AGENDA
Regular Hybrid Meeting
Town of Granby
Inland Wetlands and Watercourses Commission
Wednesday, July 9, 2025, at 7:00 pm
Town Hall Meeting Room

This letter is being submitted by Kimley-Horn & Associates, Inc. on behalf of AutoZone, Inc. ("Applicant") in response to the department review letters listed below:

AUTOZONE GRANBY

8 E GRANBY ROAD
GRANBY, CT 06035

SHEET NUMBER
C-5.0

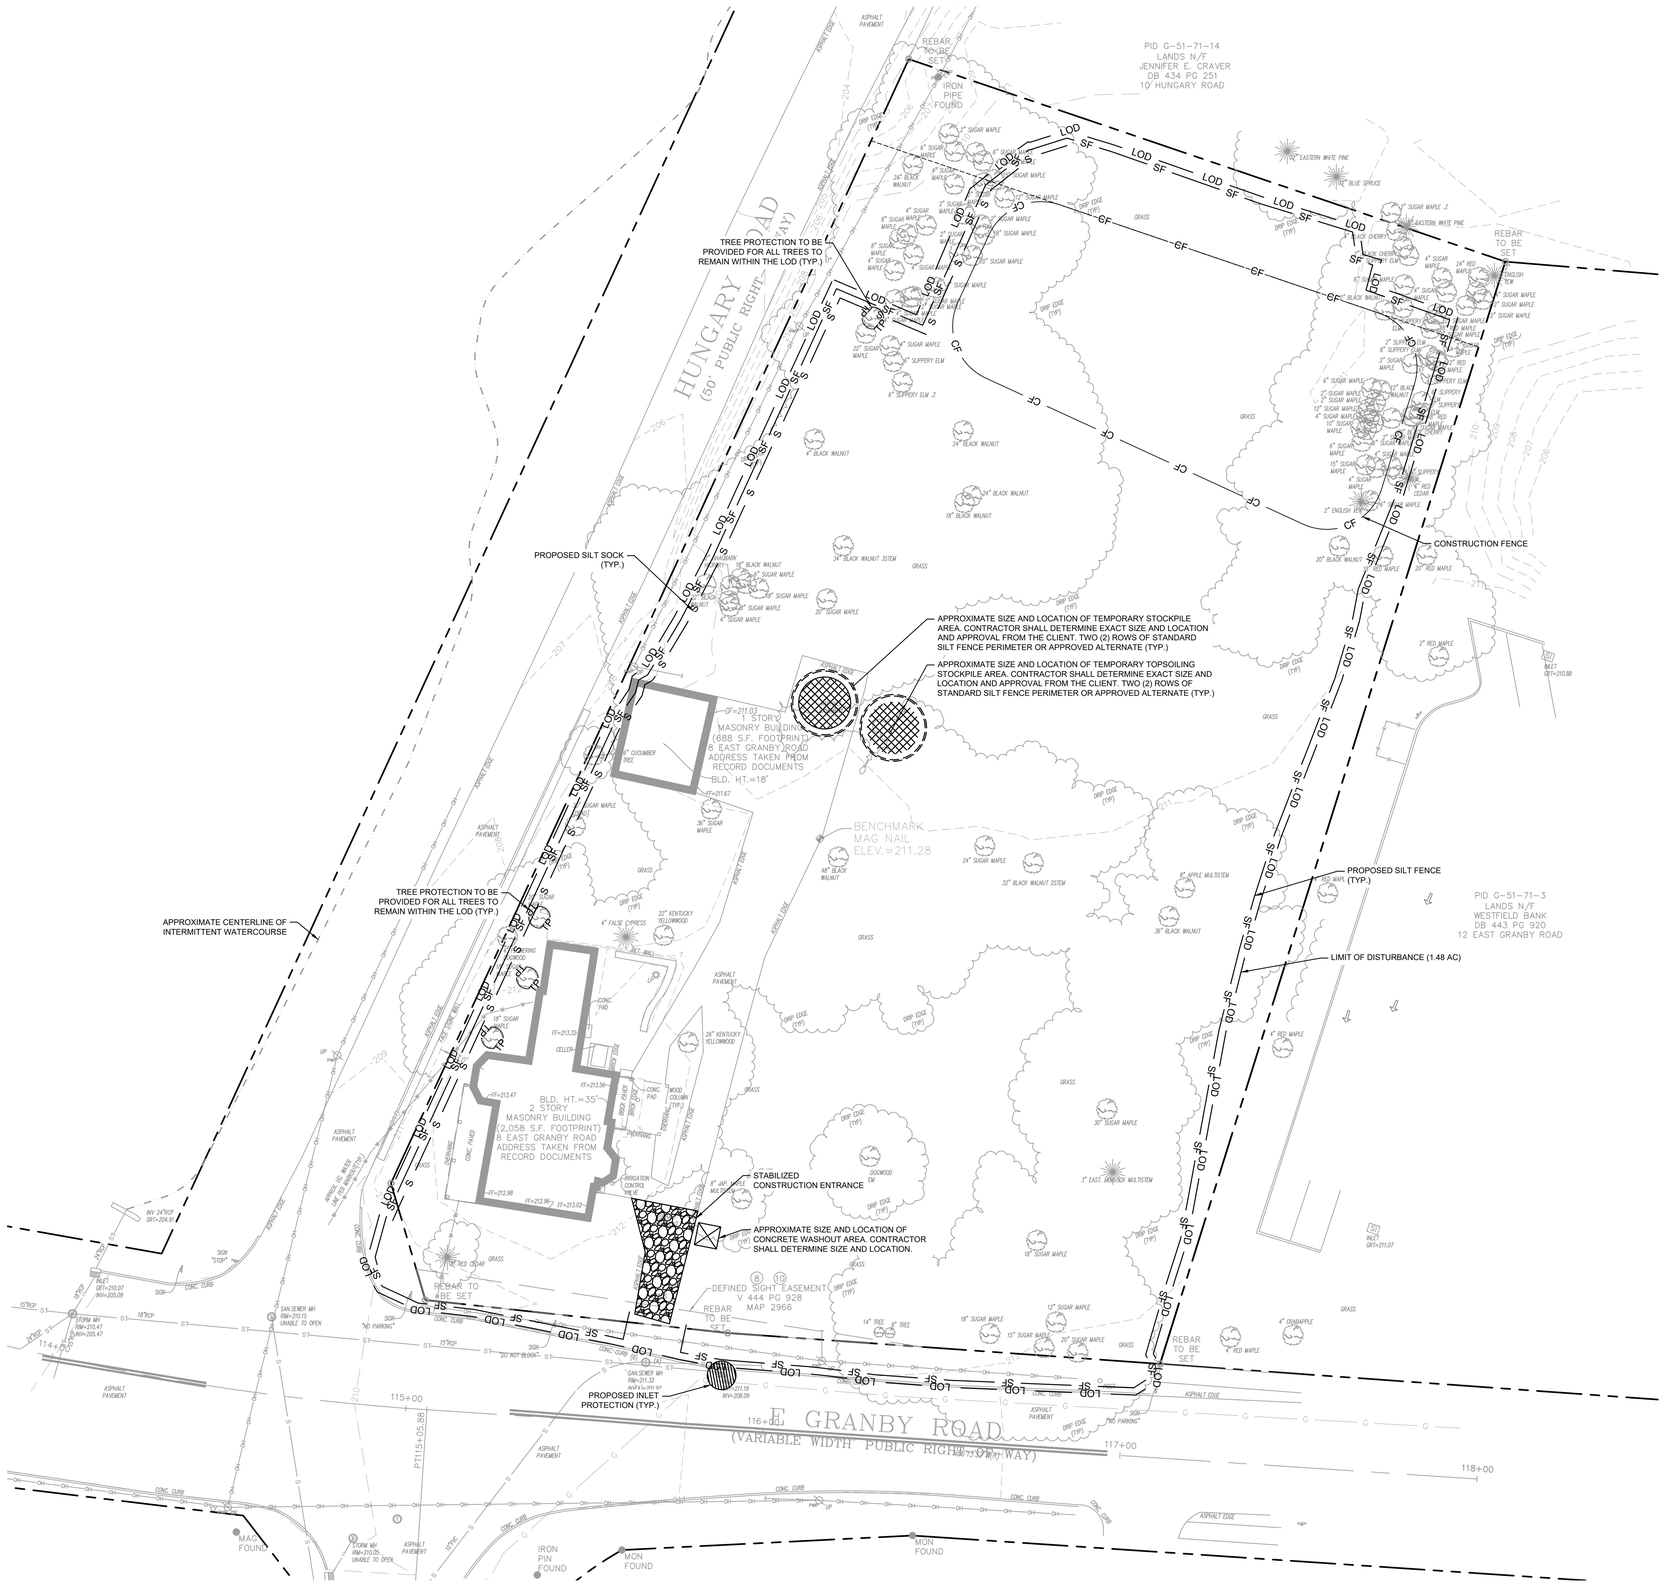
8. Show tree protection where its required.

3. Sheet C-5.0 shows silt fence to be specified as a perimeter erosion control barrier enclosing the entire disturbance area. It is recommended that a more robust perimeter control be located along the westerly property boundary, to aid in protecting the adjacent watercourse, where there is a slope adjacent to Hungary Road.

Response: Sheet C-5.0 has been revised to show tree protection where required.

Response: Sheets C-5.0 and C-5.1 have been revised to include an additional row of silt sock before the silt fence on the western property boundary per discussion with Kate Bednaz on 6/5/2025.

SHEET NUMBER
C-5.1

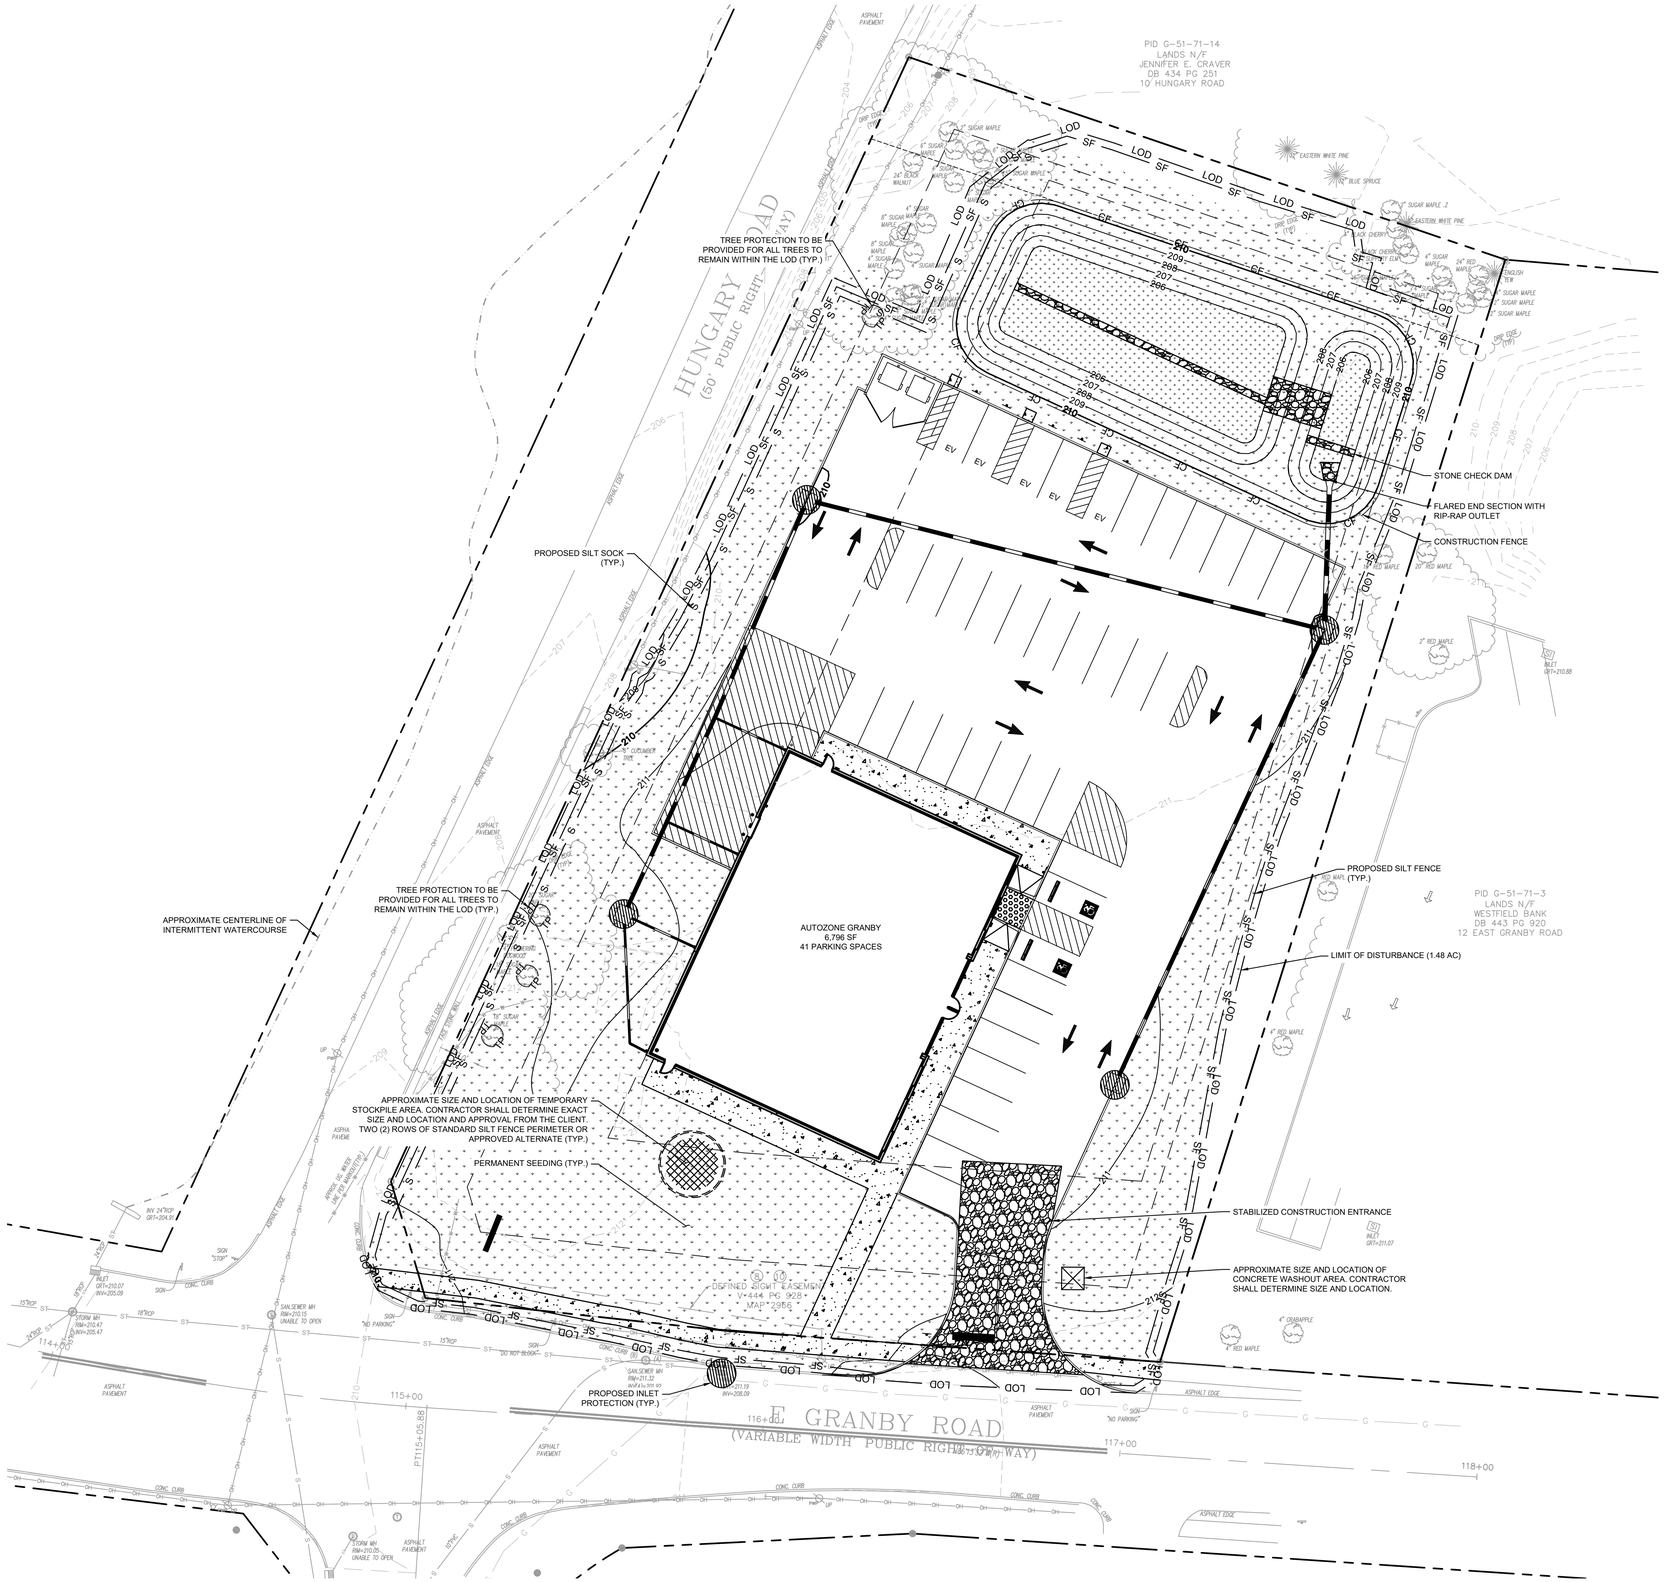
9. Show outlet protection for pipes that will discharge into the infiltration basin. Include stone check dams to protect the area outside of the outlet protection. This will limit the spread of sediment in the forebay.

10. Show proposed stabilization for the basin (e.g. seeding, ECM). Show protection of the basin during construction.

Response: Sheet 3.0 and Sheet C-5.1 have been revised to show a flared end section with associated rip-rap and stone check dam to meet out

Response: Sheet C-5.0 and C-5.1 have been revised to show the proposed stabilization and protection of the infiltration basin.

SHEET NUMBER
L-1.0

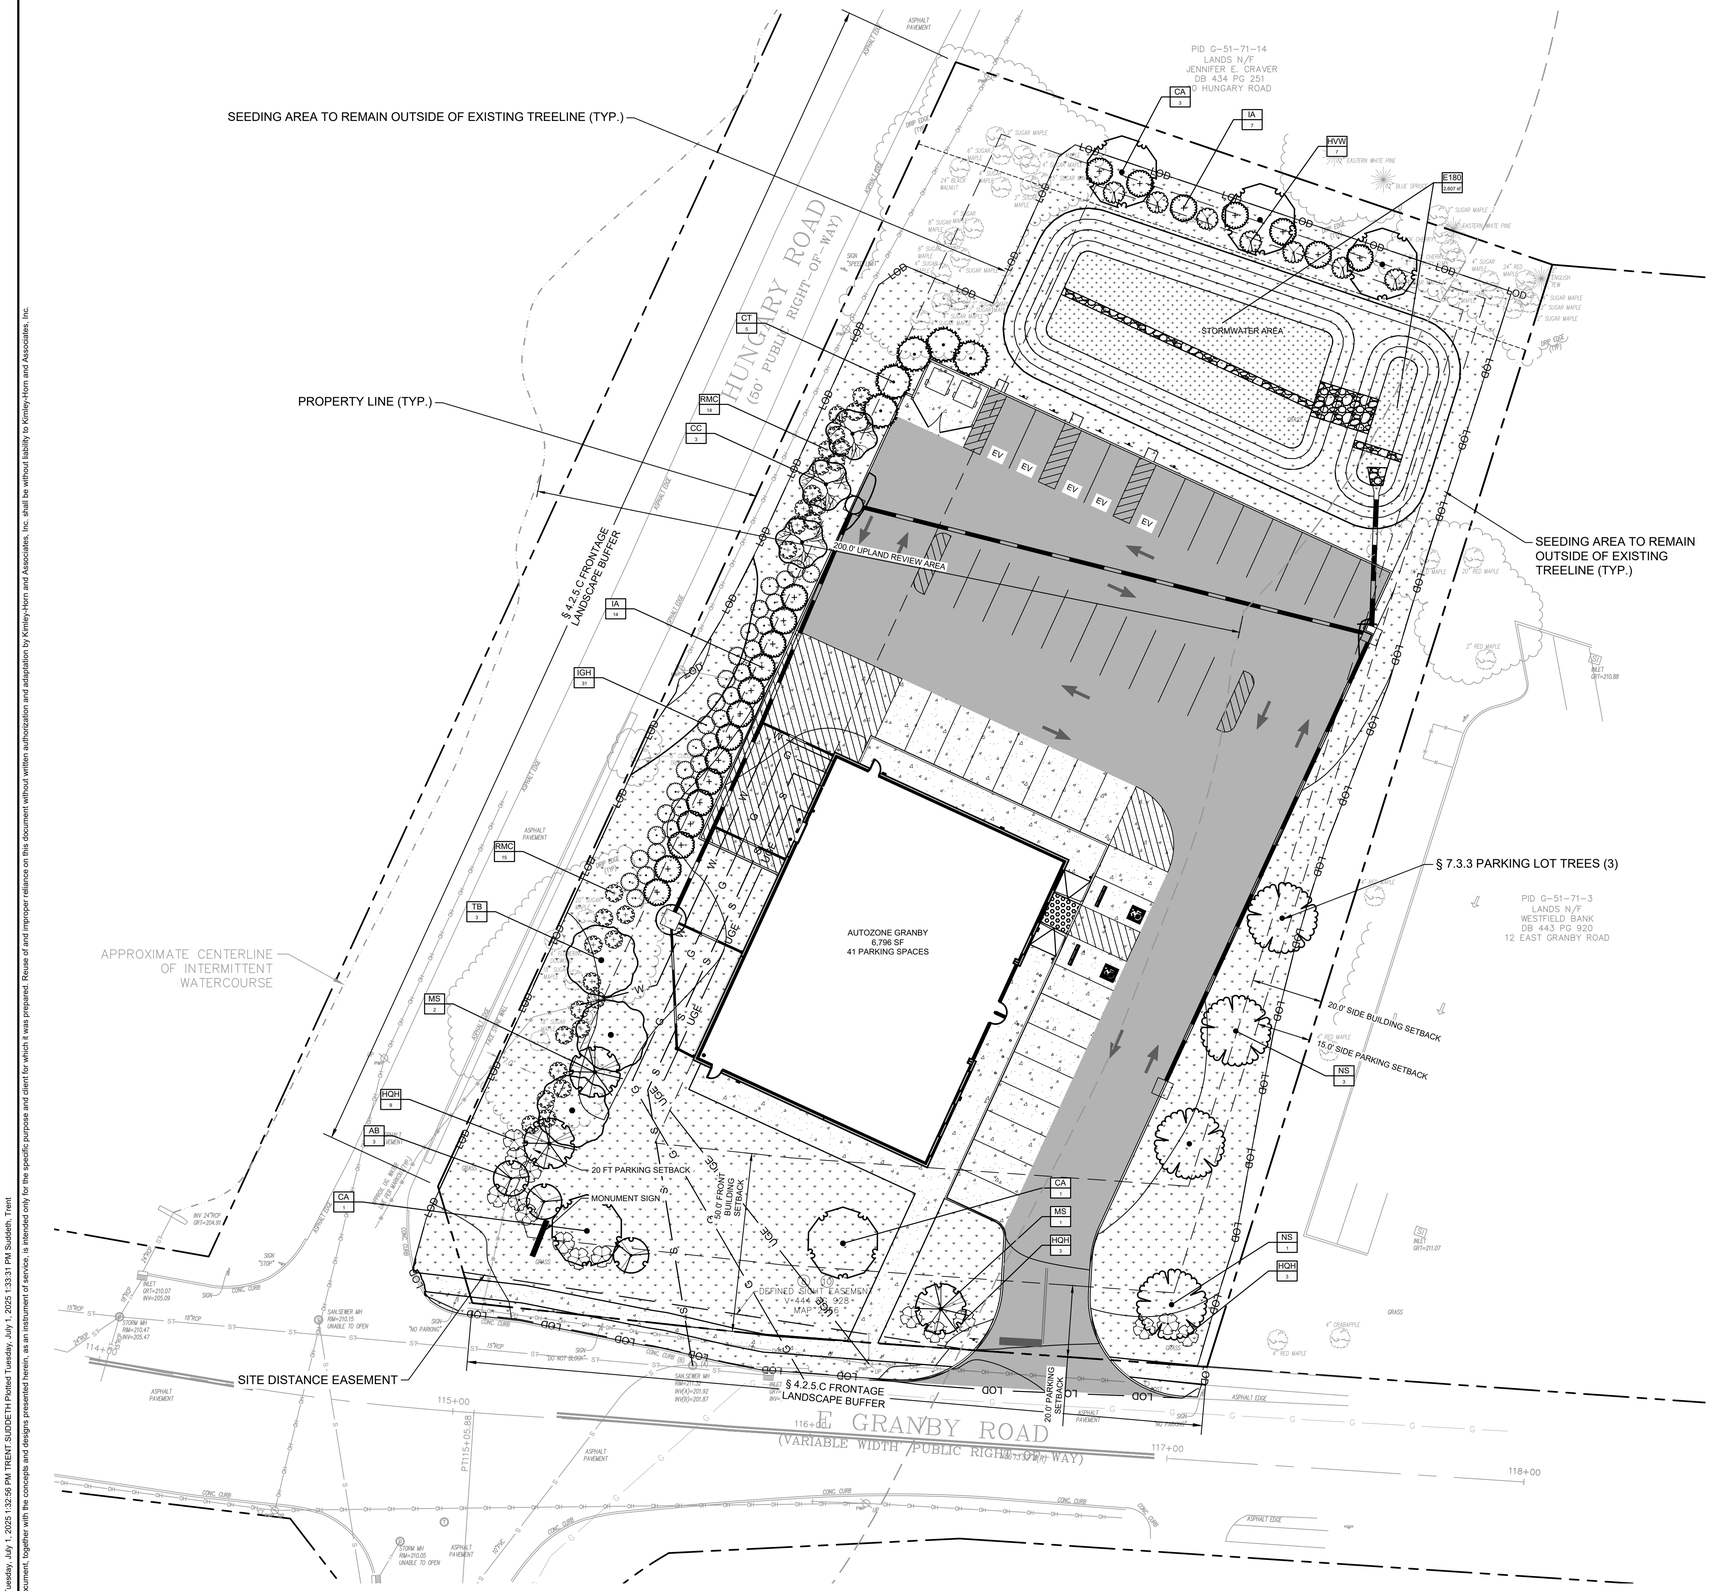
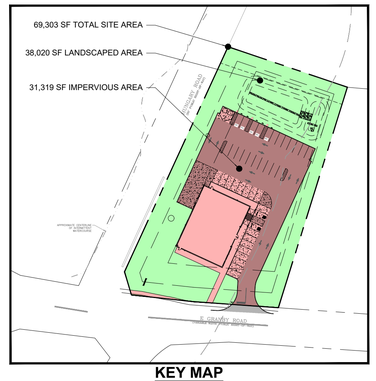
2. I do not see a landscape plan. Typically IWWC will want to see this as part of the application, specifically plantings within the URA.

Response: A landscape plan and notes have been added to the planset as Sheets L-1.0 & L-1.1.

Response: A 25-foot landscape buffer is provided at the north of the property. The extents of the infiltration basin have been revised to be outside the 25-foot buffer. Landscaping has been added and is shown on Sheet L-1.0.
